REGIONAL REVIEW FINDING

ARC REVIEW CODE: R1703071

Name of Proposal: Woodbury Park E-Commerce & Distribution Center (DRI 2654)

WOODBURY CENTER DRI
Fulton County
Natural Resources Division Review Comments
March 2, 2017

GRTA DRI SITE PLAN

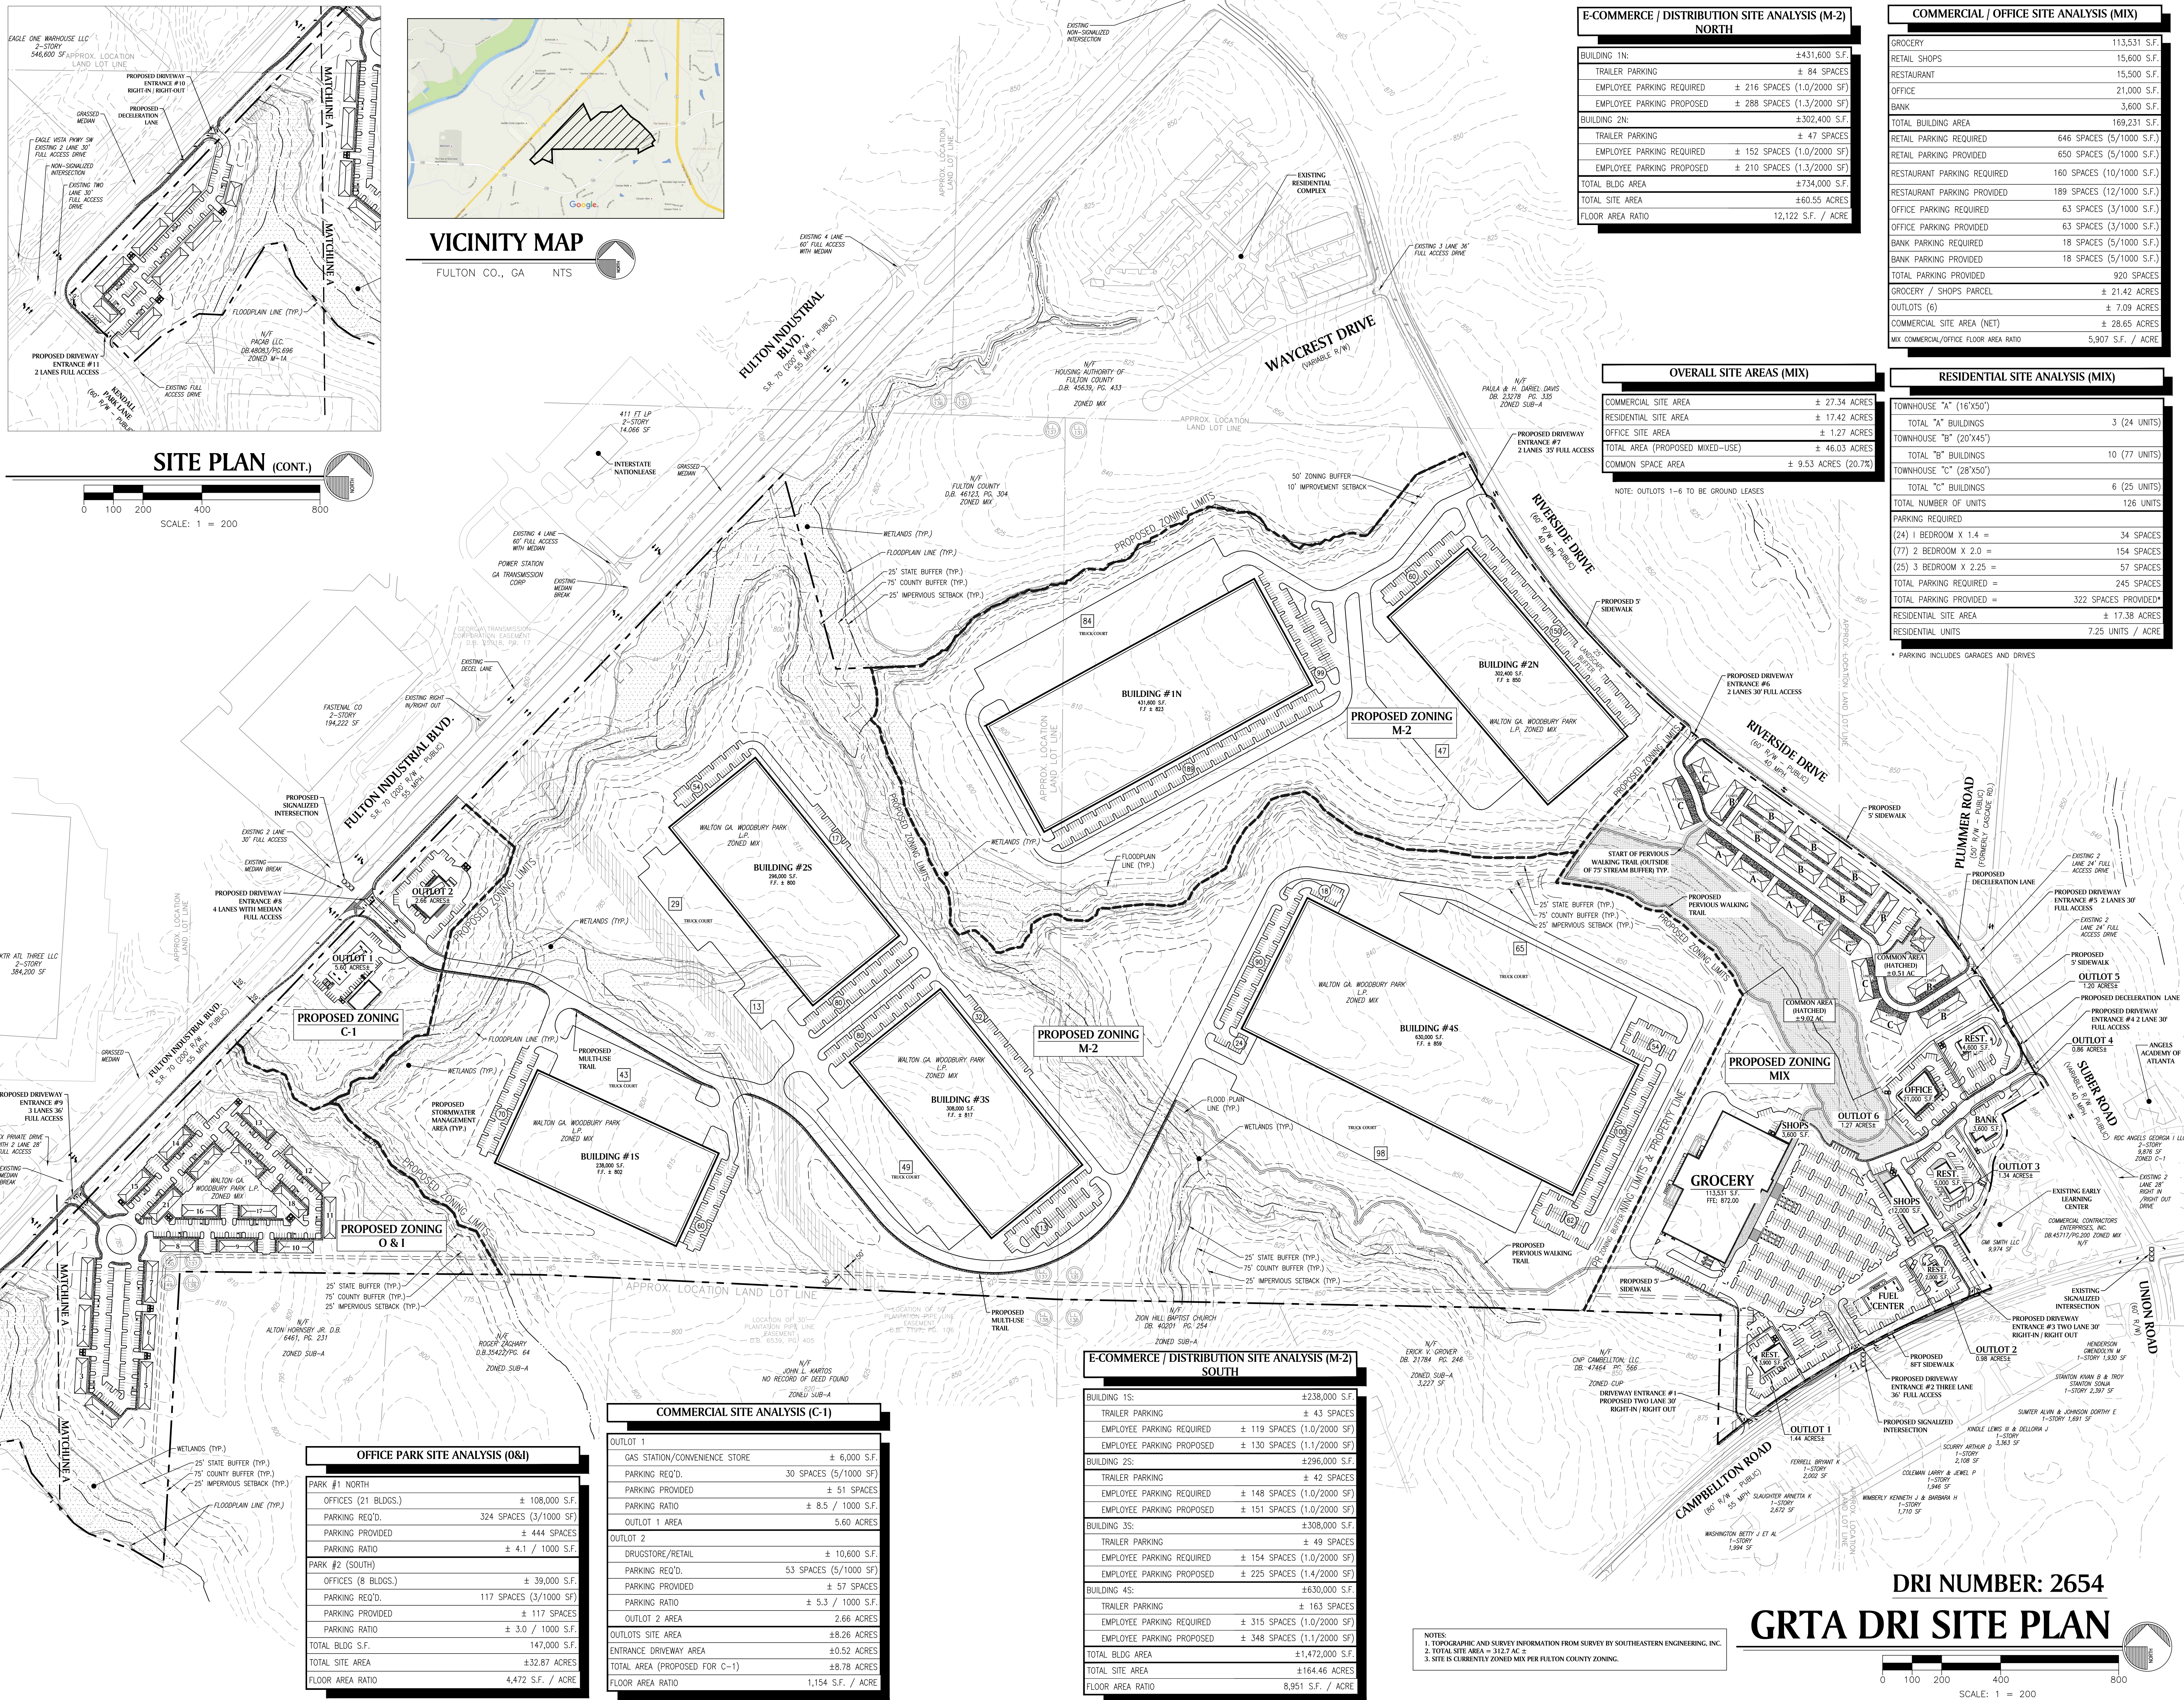
The USGS coverage for the project area shows two blue line streams on the project property. The submitted project site plan shows these streams as well as others running through the project property. The site plan shows the 75-foot undisturbed buffer required by the Fulton Stream Buffer Ordinance and the State 25-foot State Erosion and Sedimentation Act buffer along both banks of all indicated streams, as well as an additional 25-foot impervious surface setback shown on the larger streams. Any land disturbance or development in these buffers will require variances from the appropriate agencies. Any unmapped streams on the property may also be subject to the County Stream Buffer Ordinance and any other state waters that may be on the property will be subject to the requirements of the State 25-foot Erosion and Sedimentation Act buffer.

The site plan and traffic analysis indicates eleven (11) site access points: three (3) on Fulton Industrial Blvd (SR 70), four (4) on Riverside Drive, three (3) Campbellton Road (SR 154) and one (1) on Kendal Park Lane. Fulton Industrial Blvd and Campbellton Road are designated as regional thoroughfares.

No multiuse trails are in the study area. The site plan depicts a proposed pervious walking trail within the development

The development proposes a mixture of neighborhood uses including, office, industrial warehousing, townhouses and a mix of commercial uses including banks, a grocery store, fast food and sit down restaurants, retail and shopping centers. The proposed development is bordered by mix zoned parcels and existing residential and commercial uses along Riverside Drive and Campbellton Road. Wetlands limit connectivity in some areas however there are opportunities for roadway inter parcel connectivity. No internal roadway connectivity is provided.

The site plan and traffic analysis does not propose bicycle and pedestrian facilities being provided throughout the development site. Sidewalks are proposed on Riverside Drive and Campbellton Road adjacent to the development site. Natural barriers, such as streams, create some limitations on maneuverability and accessibility within the site. Limited pedestrian facilities are proposed for the

commercial section of the development. In some areas, pedestrian traffic appears to intermingle with vehicular traffic with no indication of separate pedestrian facilities being provided for the different modes.

External connectivity with adjacent parcels is planned for the development. Sidewalks are proposed on all roadways adjacent to the development site. Internal bicycle and pedestrian connectivity with adjacent parcels is not provided.

Industrial uses are separated from other uses in the development limiting vehicular traffic interaction with freight traffic. Freight traffic serving the industrial use may gain access from Fulton Industrial Blvd or Campbellton Road along with vehicular and pedestrian traffic to the site. Pedestrian facilities are provided along majority of the internal driveway separating pedestrian from truck and vehicle traffic.

With the goal of safety and congestion reduction for all modes of travel in mind, it is the policy of the ARC to encourage sound transportation practices to be incorporated in each development. It is recommended that, where feasible, vehicular and pedestrian connectivity with adjacent parcels be considered and incorporated within the development. Also, consider adding more accommodations for pedestrian and bicycle facilities internal to the site in the commercial phase of the development at a minimum. Minimize safety concerns by reducing pedestrian interface with vehicle and truck traffic in high traffic areas (Entrance 3) .
